Project	IEEE 802.16 Broadband Wireless Access Working Group < http://ieee802.org/16 >	
Title	Frame Structure for Transparent Relay Mode	
Date Submitted	2007-01-08	
Source(s)	Gang Shen, Kaibin Zhang, Xiaobin Leng, Jimin Liu, Shan Jin Alcatel-Lucent, Research & Innovation 388#, Ningqiao Road, Shanghai, China.	Voice: 86-21-50551240-8194 Fax: 86-21-50554554 Email: gang.a.shen@alcatel-sbell.com.cn
	Torsten Fahldieck, Joerg Schaepperle, Roland Muenzner Alcatel-Lucent, Research & Innovation Lorenzstr. 10, D-70435 Stuttgart, Germany	Voice: 49-711-82132163 Email: torsten.fahldieck@alcatel.de
	Fang-Ching Ren, I-Kang Fu, Chie Ming Chou Industrial Technology Research Institute (ITRI) EE Building 2 R442 No.1, Sec. 4, Roosevelt Road, Taipei, Taiwan 106, China.	Voice : 886-3-5914786 Fax: 886-3-5820371 Email: frank_ren@itri.org.tw
	Michiharu Nakamura , Fujitsu Laboratories Ltd. 5-5 Hikarino-oka, Yokosuka-shi, Kanagawa- ken, 239-0847 Japan	Voice : 81-468-39-5371 Fax : 81-468-39-5560 Email : michi@labs.fujitsu.com

Frame Structure for Transparent Relay Mode

Figure xxx Example of minimum configuration for an in-band transparent relay frame structure

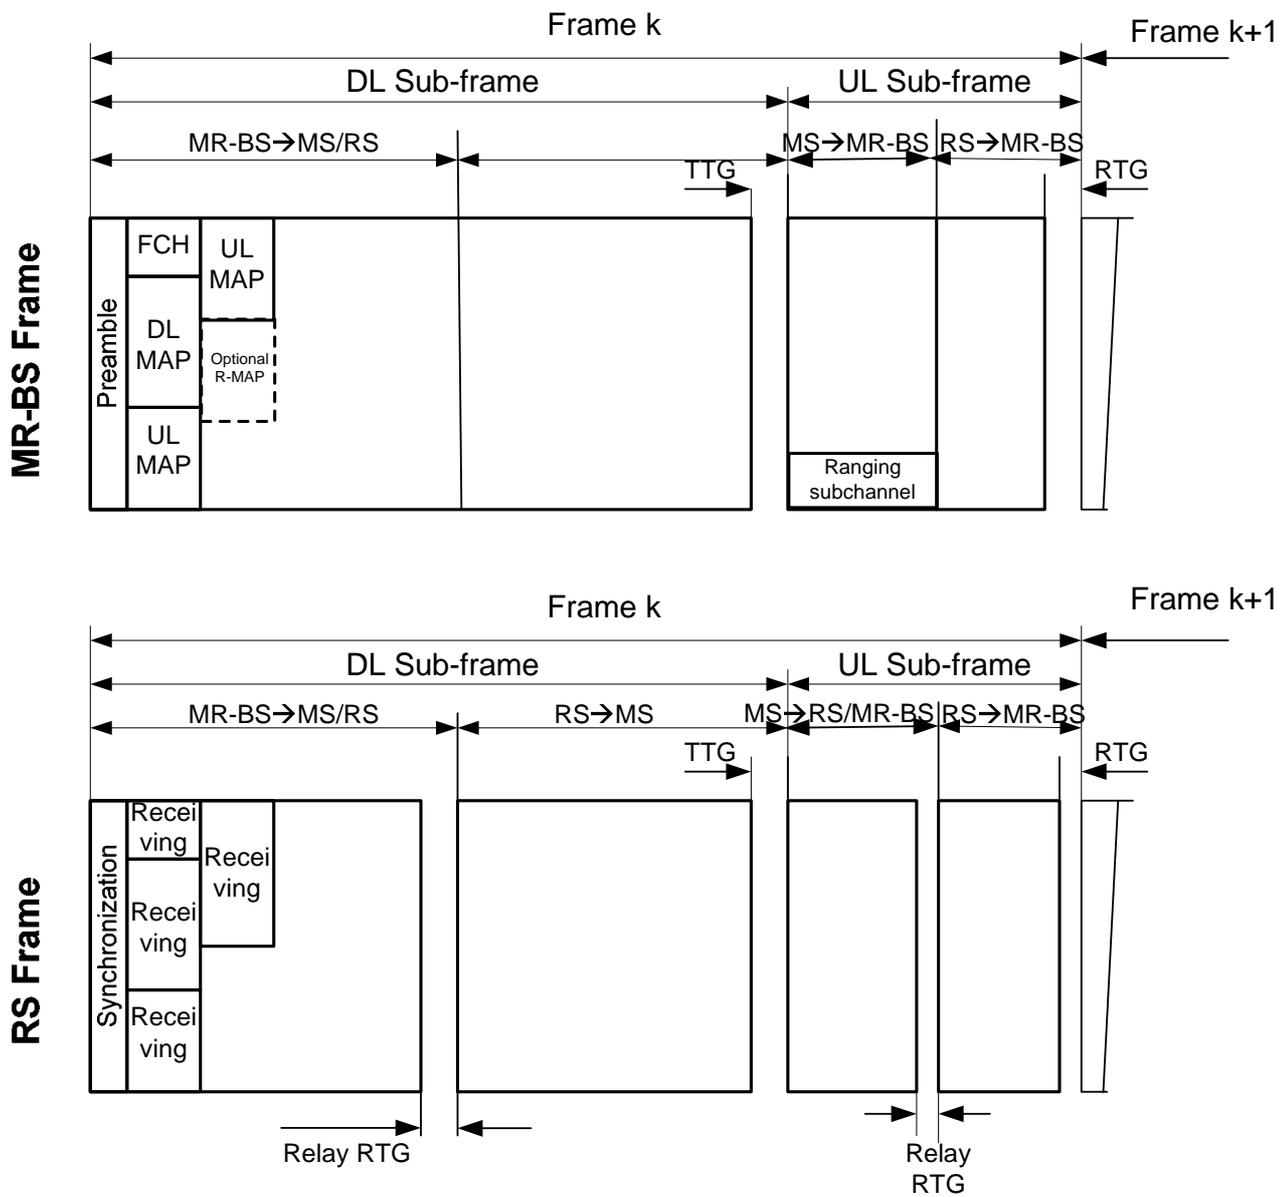
8.4.4.7.1.1 MR-BS frame structure

For the TDD mode, an example of the MR-BS frame structure is shown in Figure xxx.

Each frame in the downlink transmission begins with a preamble followed by an FCH, DL-MAP, and possibly UL-MAP. R-MAP is located following legacy MAP or defined as an extension of legacy MAP. The frame structure consists of DL sub-frame period and UL sub-frame period. In each frame, the TTG shall be inserted

between the DL sub-frame and the UL sub-frame. The RTG shall be inserted at the end of each frame. One common ranging subchannel is shared by all RSs and MSs within one MR-cell.

The DL sub-frame shall include at least one zone for MR-BS to its subordinate MR/RS transmissions and may optionally include a transparent access zone / region for RS to MS transmissions. The transparent access zone can be indicated by `STC_DL_ZONE_IE()` defined in Table 279. The UL sub-frame may include a zone for MS to MR-BS / RS transmissions and optionally include a zone for RS to MR-BS transmissions. The bandwidth allocation for transmissions between MR-BS and MS / RS follows legacy IEEE802.16e operation.
